SUBJECT: PALISADES NUCLEAR PLANT – SUMMARY OF CONFERENCE CALL  
REGARDING THE SPRING 2012 STEAM GENERATOR INSPECTIONS  
(TAC NO. ME8129)

## CONFERENCE CALL SUMMARY

### PALISADES NUCLEAR PLANT SPRING 2012 (1R22) OUTAGE STEAM GENERATOR

## **STEAM GENERATOR TUBE INSPECTION DISCUSSION DURING PALISADES 2012 (1R22) OUTAGE**

Refer to attached Primary to Secondary Leak Rate for Operational Cycle 22 Primary to Secondary Leak Rate graph. Leakage has been minimal all cycle

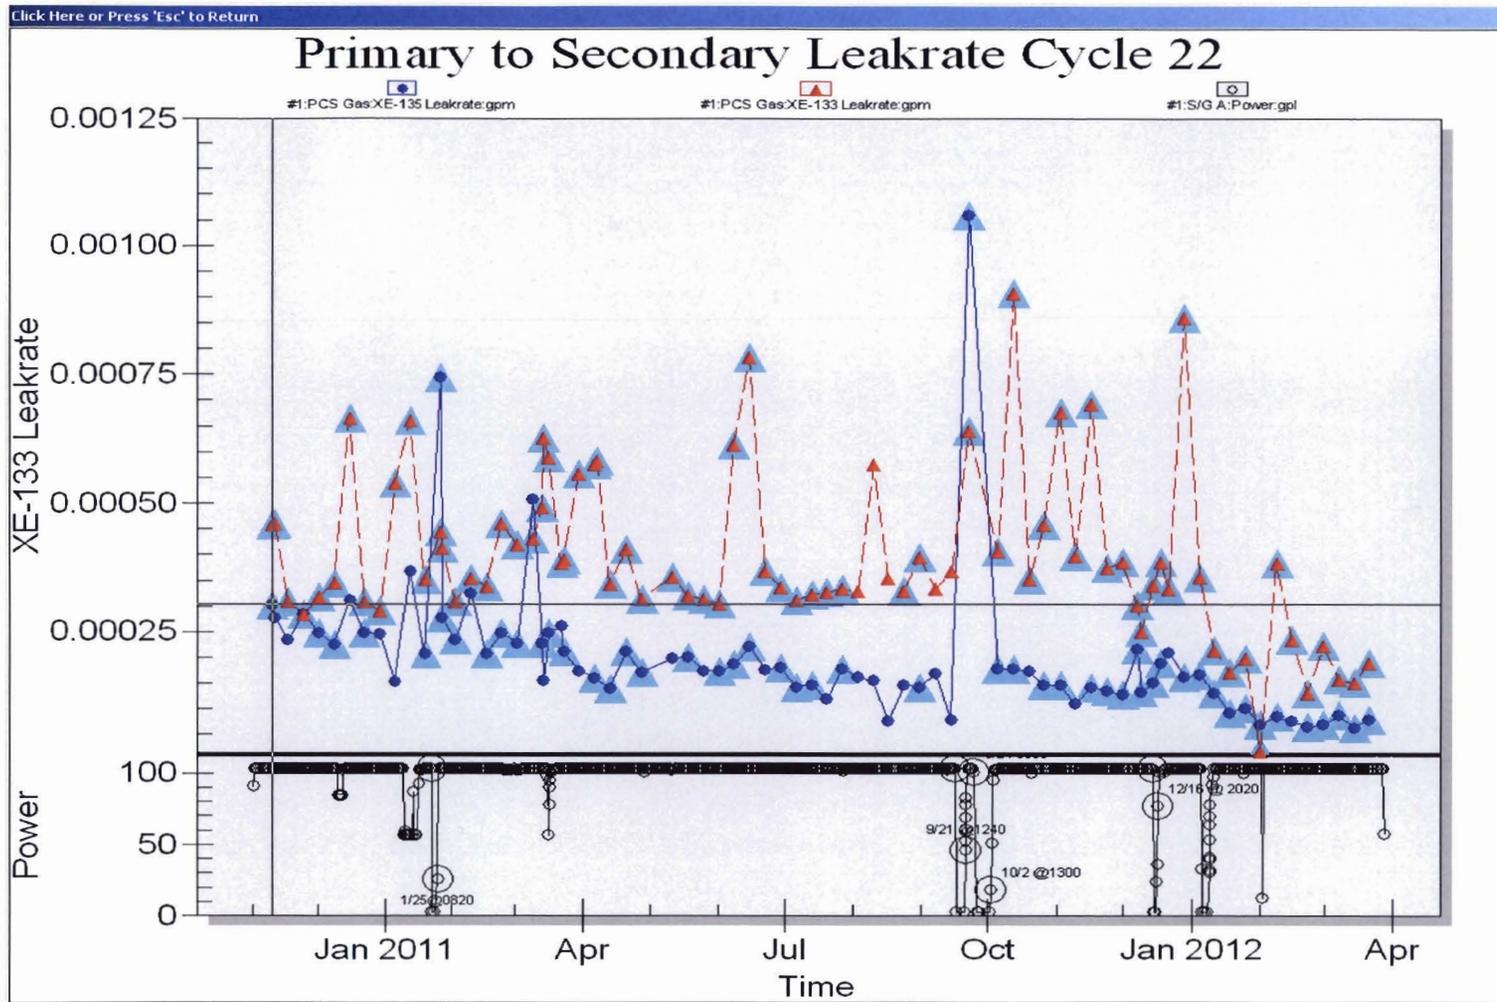
### **1. Discuss any trends in the amount of primary-to-secondary leakage observed during the recently completed cycle.**
